Agency of Transportation

RE: BRIGHTON ER STP 034-3(25) CONTRACTOR EPSC PLAN REVIEW

Brighton ER STP 034-3(25) Contractor Erosion Prevention and Sediment Control Plan

PROJECT NAME: BRIGHTON	PLOT DATE: 12-SEP-2012
PROJECT NUMBER: ER STP 034-3(25)	DRAWN BY: J. SALVATORI
FILE NAME: #1b2080epsc.dgn	CHECKED BY: W. LAMMER
PROJECT LEADER: K. HIGGINS	SHEET 26 OF 36
DESIGNED BY: J. SALVATORI	
EPSC PLAN

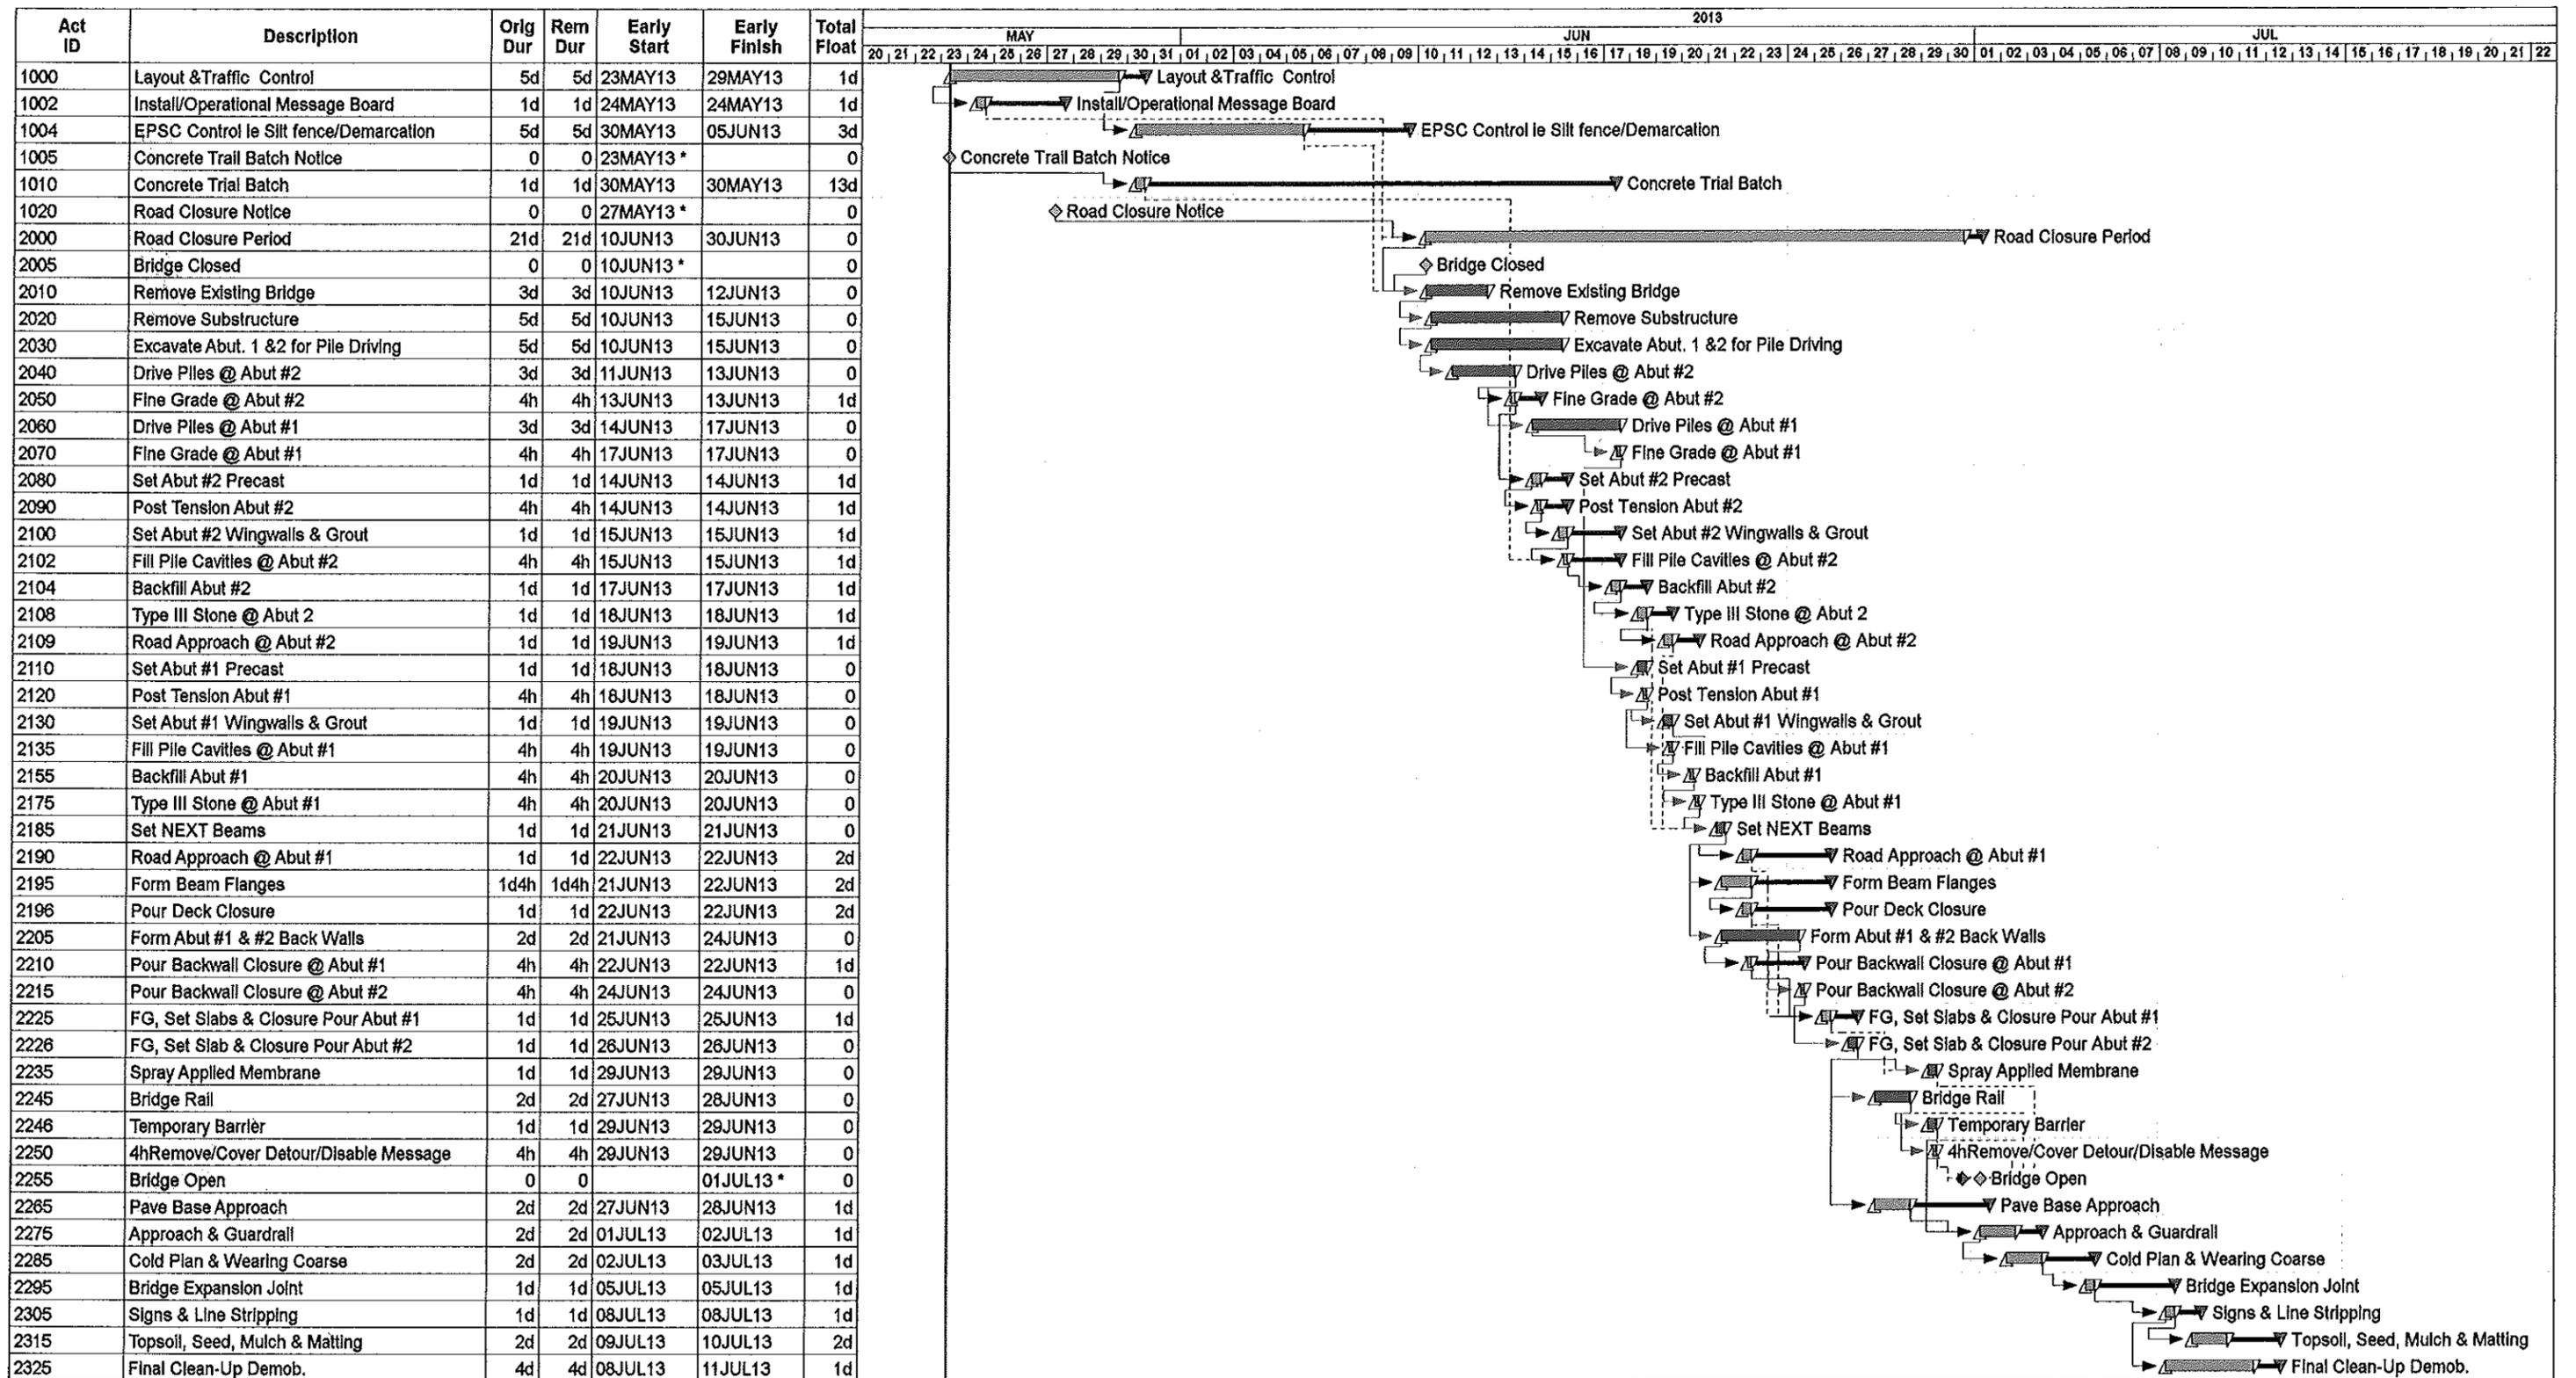
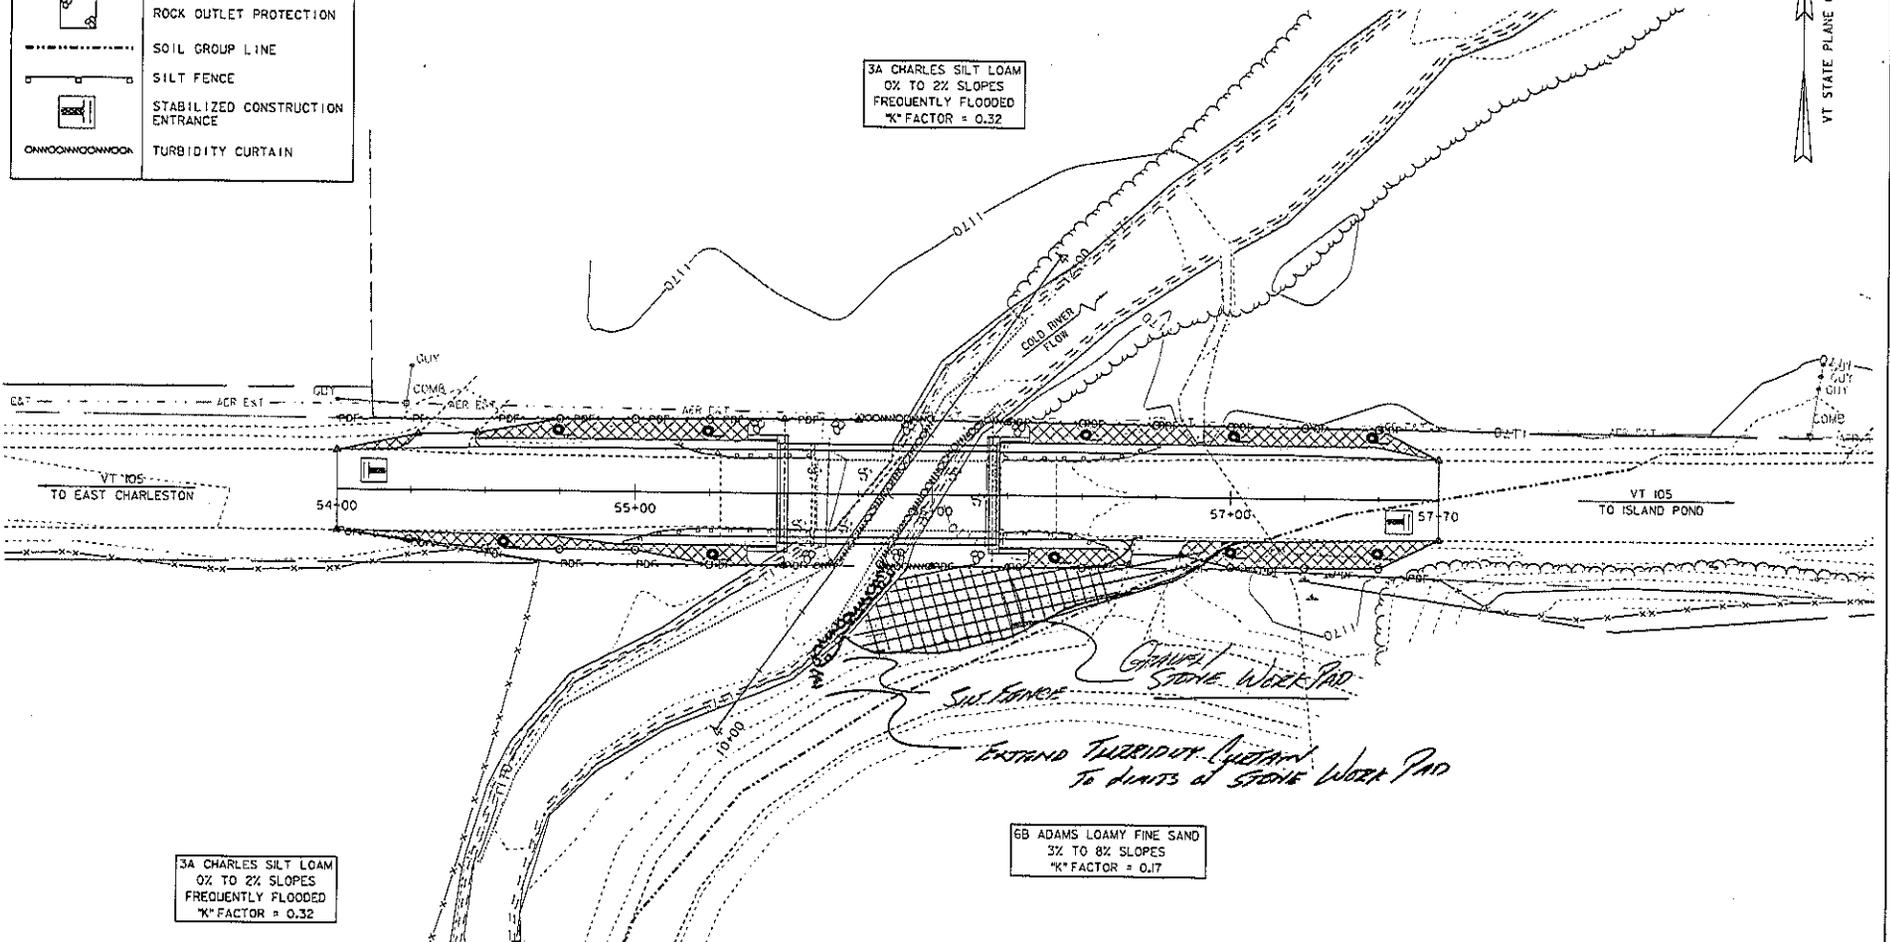
The only real change to the Contract EPSC Plan is the installation of an access area (described in the Narrative as SE corner of Abutment 1 at STA 56+00 LT and shown on a plan sheet as upstream of Abutment 2 in the SE quadrant (STA 56+00RT)). Regardless of the actual location, it is outside of the original contract construction limits and will therefore need review as an Off-Site Activity. I did not see any indication that dewatering is expected however the borings show a fairly high groundwater table. Should treatment of dewatering become necessary it too may need review as an off-site activity as well as an update to the EPSC Plan.
